ATOMIC INDUSTRIAL FORUM INC.

August 9, 1961

APPENDIX "A-5"

Example of a Calculation of Reactor Siting Distances

EQUIVALENT WHOLE-BODY DOSE DUE TO IODINE INHALATION
 (300 REM TO THE THYROID = 25 REM EQUIVALENT WHOLE-BODY DOSE)
 AND
 WHOLE-BODY DIRECT RADIATION DOSE

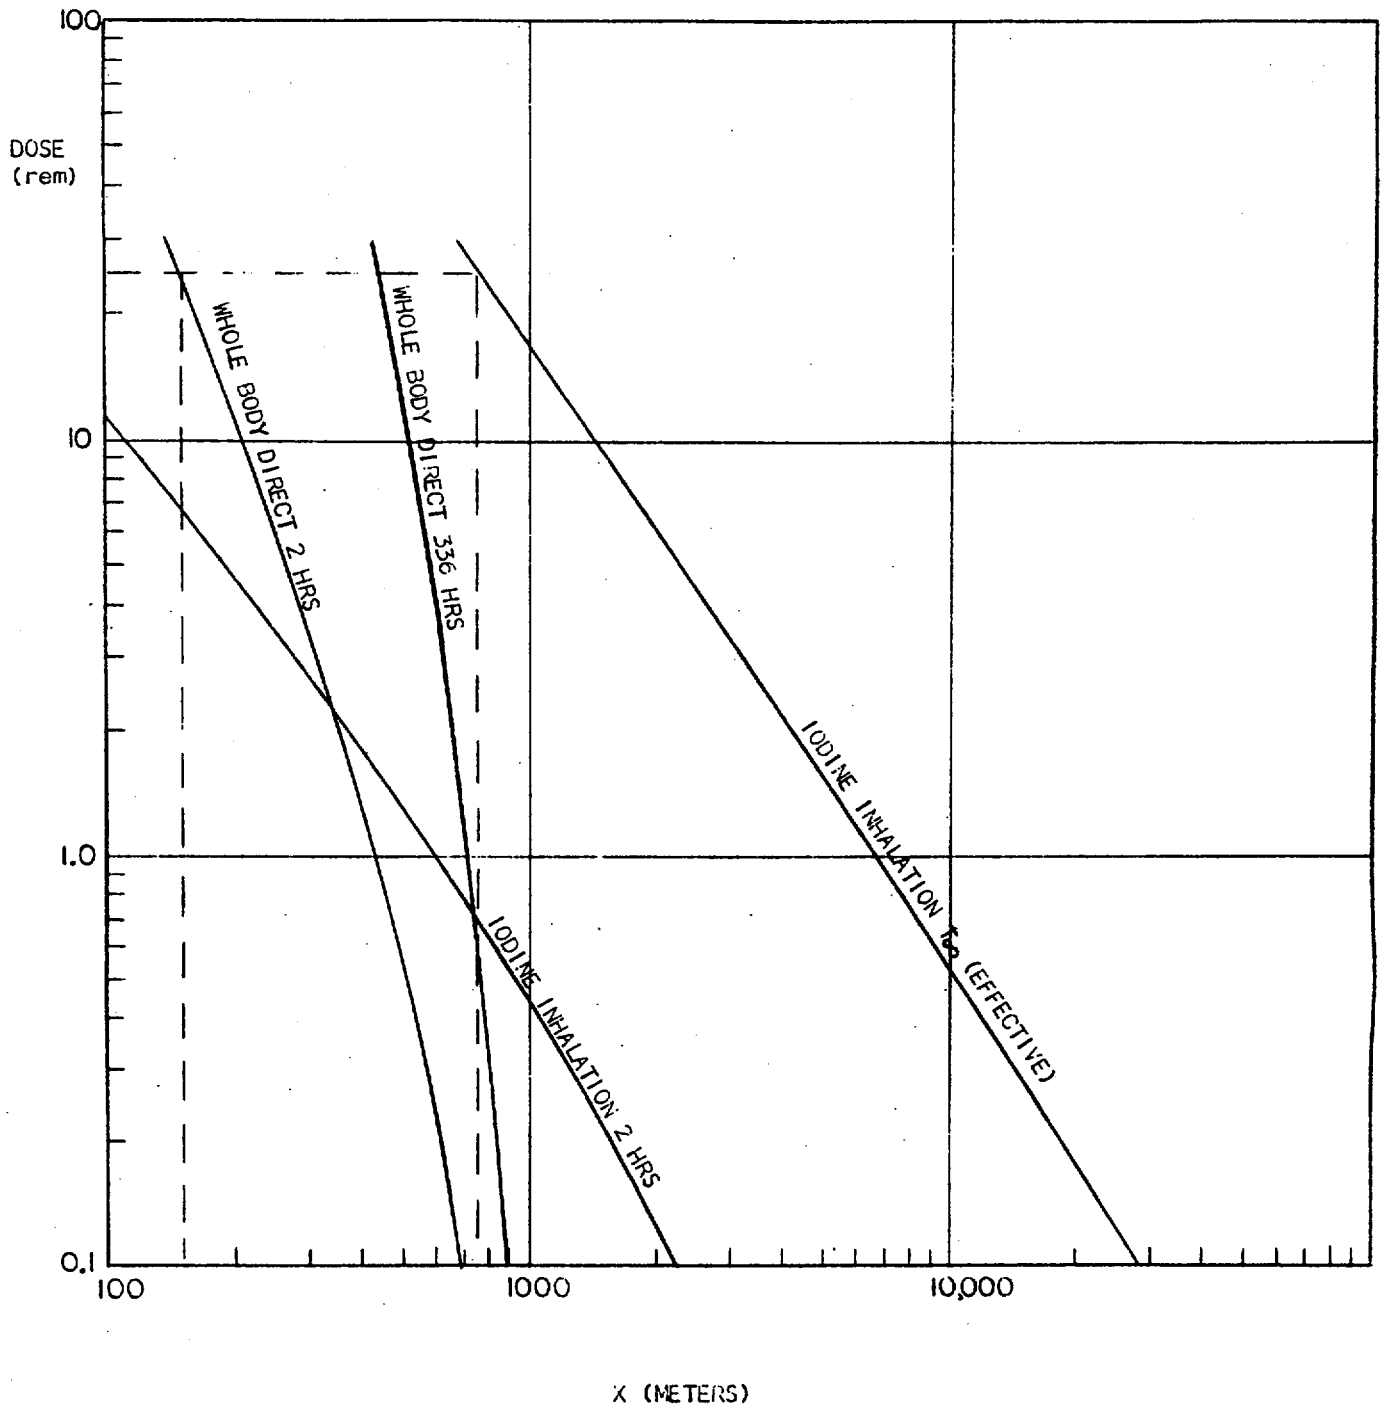
2. For the normal operating power (200 Mwth) the exclusion area boundary is 150 meters from the reactor building. This distance is governed by the whole-body dose limitation. The thyroid dose is considerably below the maximum permissible limit at this distance.

For the normal operating power the low-population zone boundary is 750 meters from the reactor building. This dose is governed by the thyroid limit. The whole-body dose is insignificant at this distance.

A graph of the functions used in these computations is given on the following page.
